#### APPEAL SUMMARY

<b>Appeal ID:</b> 20774	<b>Project Address:</b> 200 NW Royal Blvd, Lot #5
<b>Hearing Date:</b> 8/21/19	<b>Appellant Name:</b> Robert Oshatz
<b>Case No.:</b> B-010	<b>Appellant Phone:</b> 5036354243
<b>Appeal Type:</b> Building	<b>Plans Examiner/Inspector:</b> Jason Butler-Brown
<b>Project Type:</b> residential	<b>Stories:</b> 3 <b>Occupancy:</b> R <b>Construction Type:</b> V-B
<b>Building/Business Name:</b> RHO LLC	<b>Fire Sprinklers:</b> No
<b>Appeal Involves:</b> Erection of a new structure	<b>LUR or Permit Application No.:</b> 06-109711-LU
<b>Plan Submitted Option:</b> pdf [File 1] [File 2]	<b>Proposed use:</b> Single family residence

##### Appeal item 1

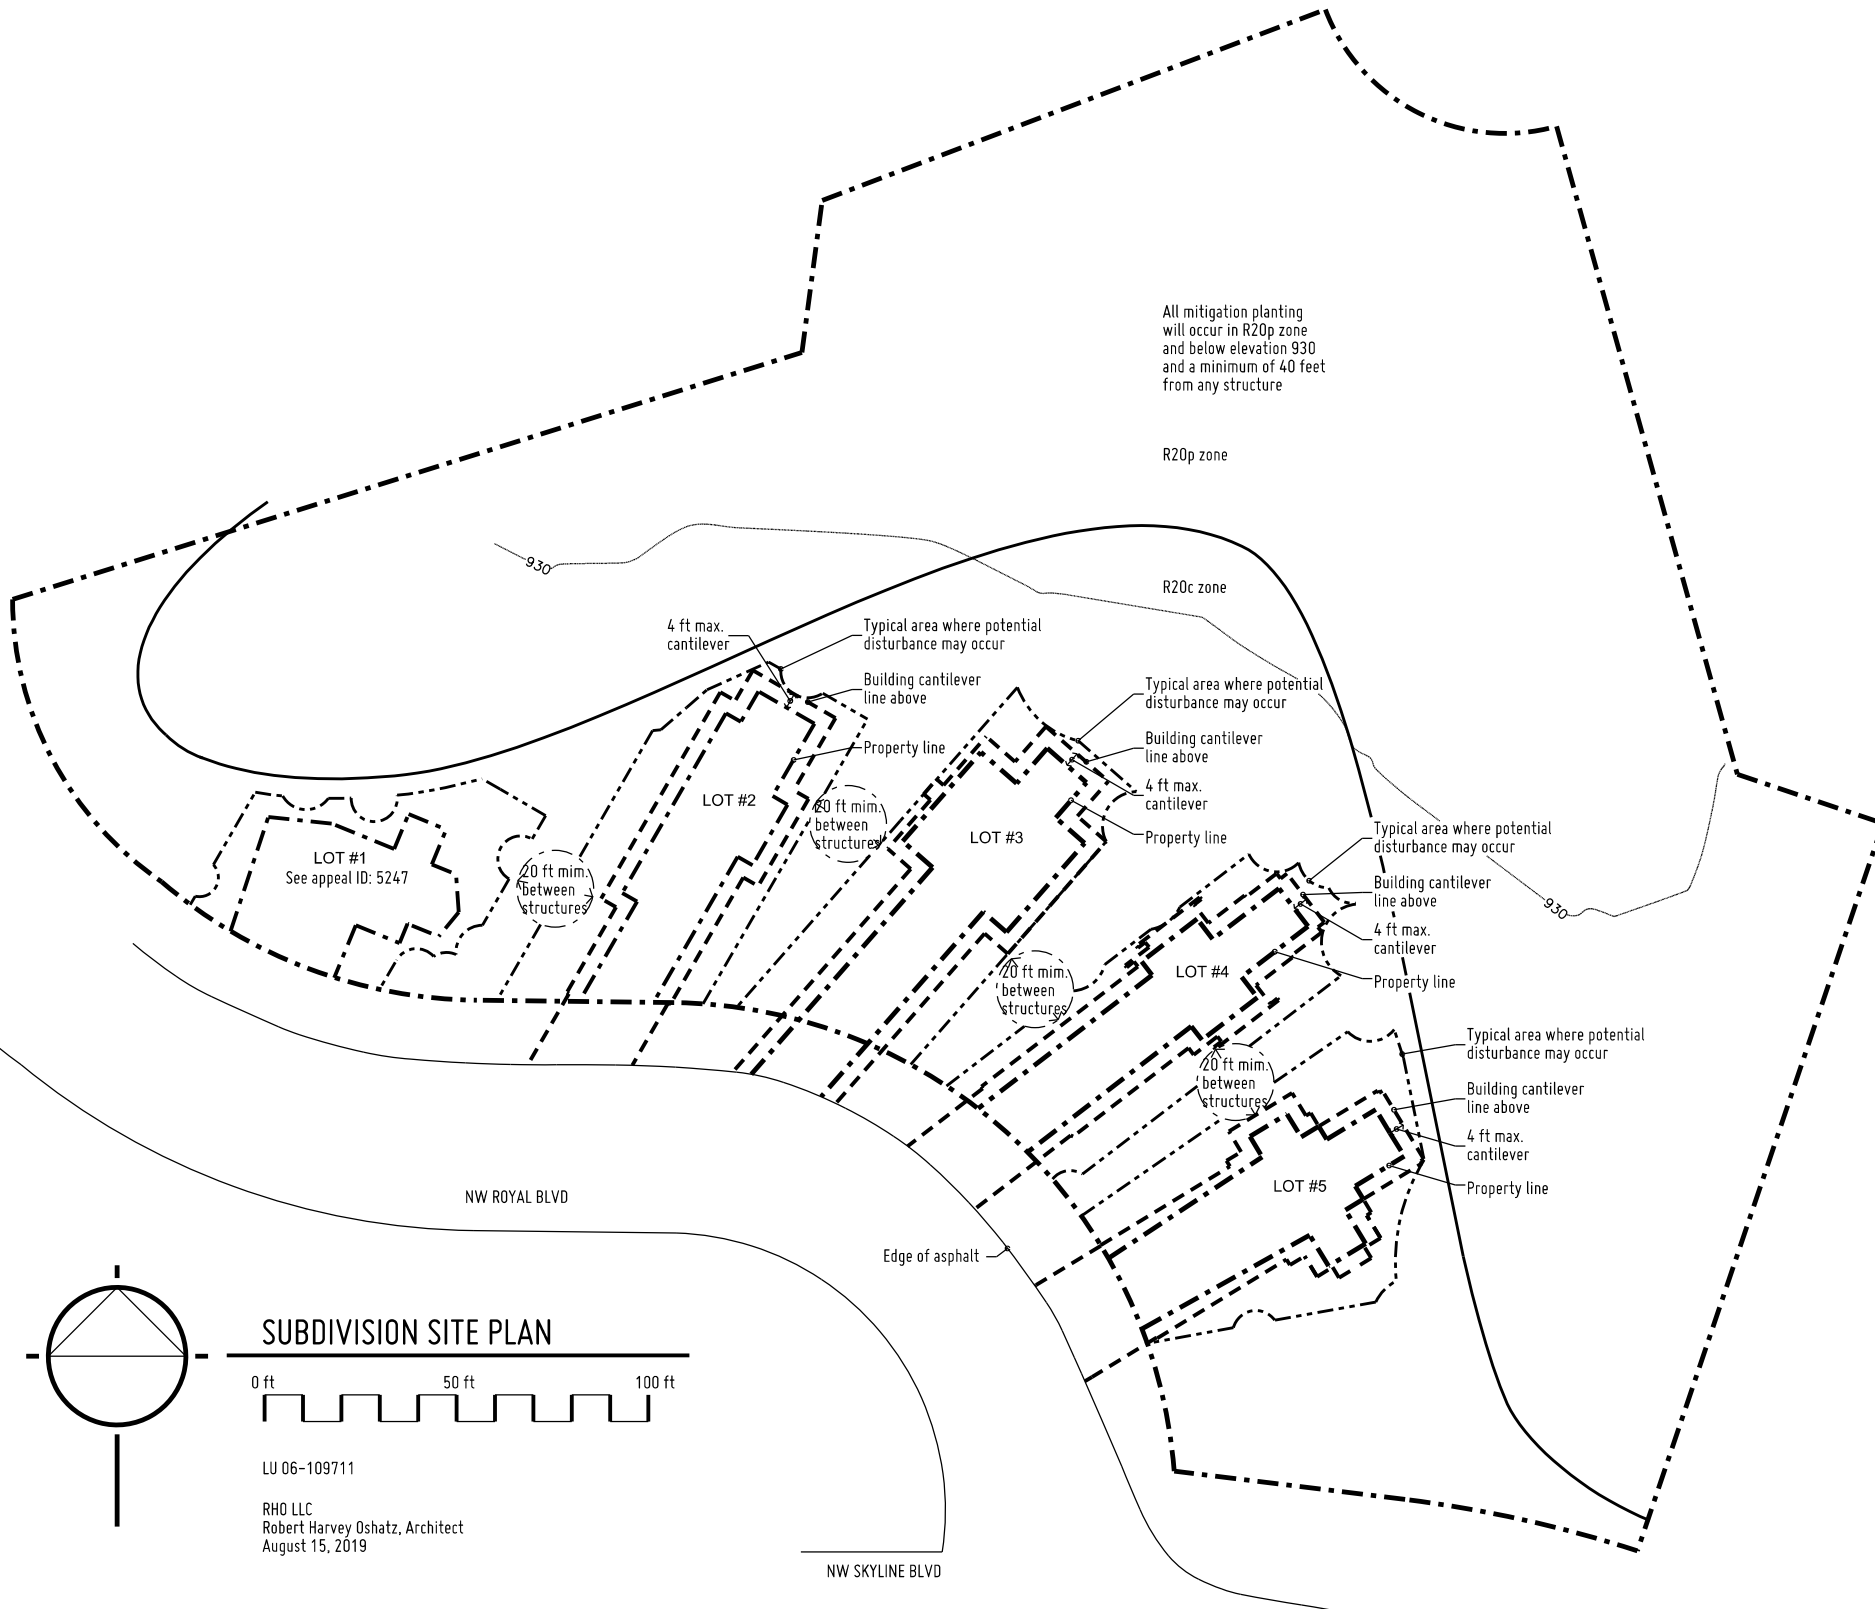
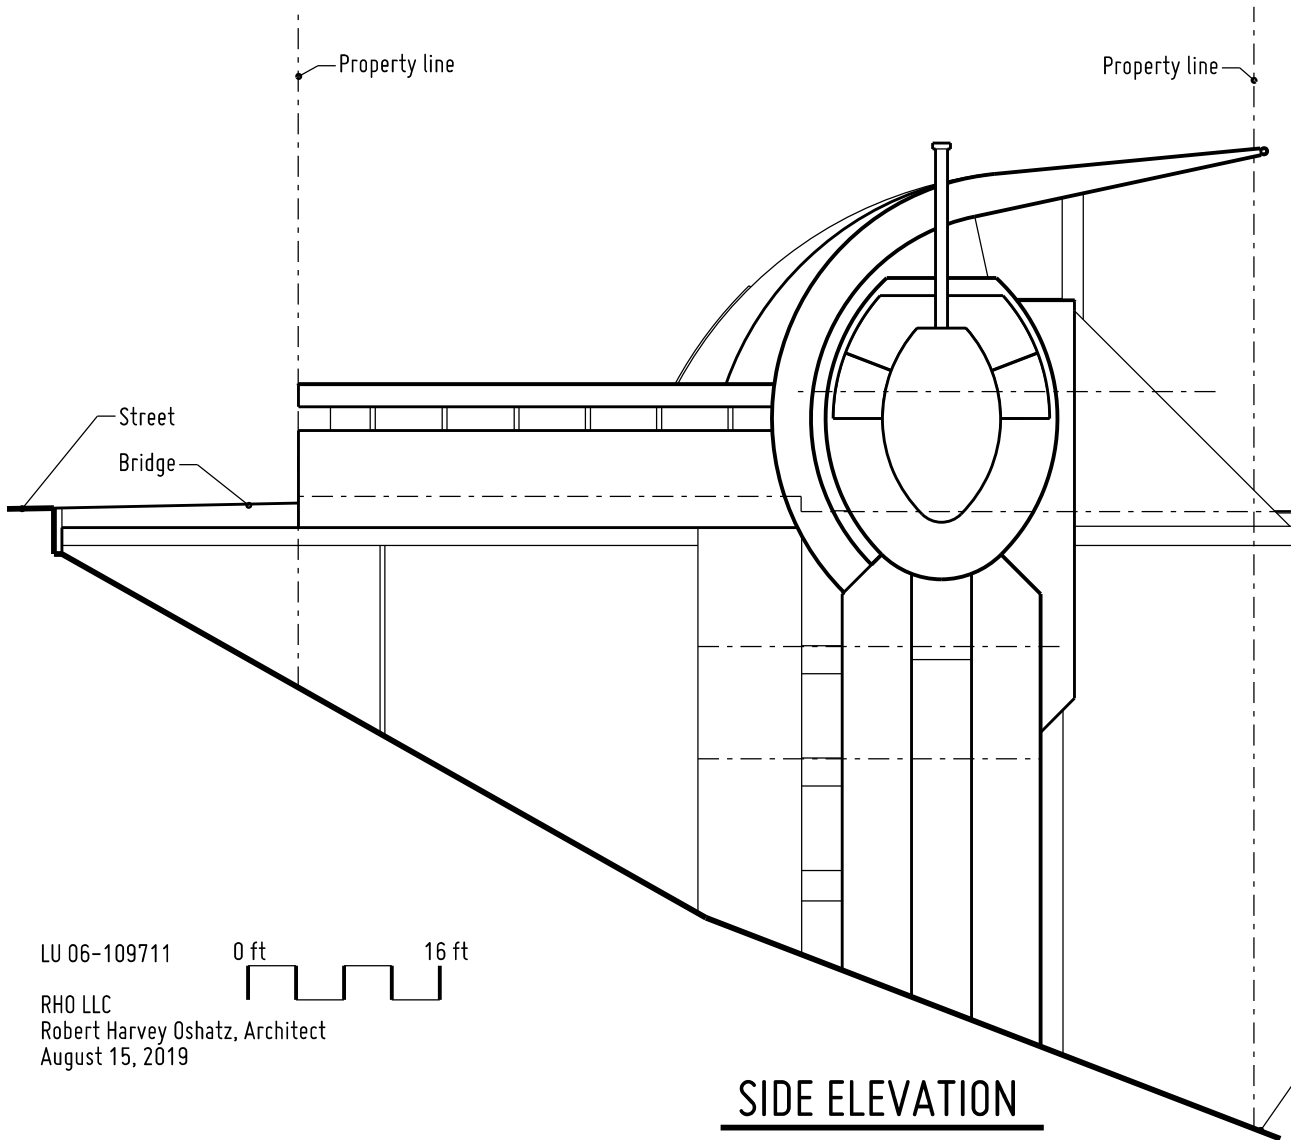
At this time, I am applying for a building code appeal on Lot #5 to cantilever as shown in the attach drawings into the subdivision private common green area. The steeply sloping downhill site requires steel H-piling supports. Horizontally at street level and supported by the piling will be a steel and wood bridge. The house will be built on top, hung from and cantilever out from the bridge. The cantilevering in a cantilever easement area beyond the individual property lines (see reason for alternate) will be of conventional wood frame construction supported by steel and engineered lumber beams. The finish exterior walls and roof will be of sheet-metal, wood and stucco siding.

Section R302.1 of the 2005 Oregon Residential Specialty Code is concerned with public safety. It requires that openings are not permitted less than 3 feet from a property line. Essentially this results in a separation of openings between structures of at least 6 feet to prevent fire spreading. In this appeal, for Lot #5 will be at least 20 feet away from any future structure on Lot #4 (as required by the subdivision approval). This is greatly exceeding the 6 feet suggested by R302.1. Thus, the design follows the intent of the code and more than satisfies it.

I feel code guide OSSC/32/#1 should not apply in this case. In the past it has been targeted for cantilevering into public common areas that is used by the public. This is a case where the structure is cantilevering into its own privately not open to the public green space. When the subdivision is look at with its private common green space (which is not open to use by the public and since the site is steeply sloping and the structures are not design for their occupants to use the private common green space) in essence the house is meeting the concerns of a residence built in a R20 zone. In reality except to meet zoning requirements of an environmentally sensitive site the property lines are imaginary (in essence the planning department is saying this by going along with the concept of cantilevering over the property lines and requiring the residence to be a minimum of 2,000 sf).

The cantilever deck which will be constructed of steel beams, 4x14 joist and 2x6 outdoor decking; the roof will be Class B materials, the walls are cad in sheet-metal, wood and stucco and soffits will be 5/8" fire rated gypsum board; making the structure at least as safe as any other residence in the neighbor. In addition, I am willing to work with the Fire Marshall's office to mitigate any of their concerns.

**Openings in exterior walls at property line: Hold for additional information.**  
**Appellant may contact John Butler (503 823-7339) with questions.**
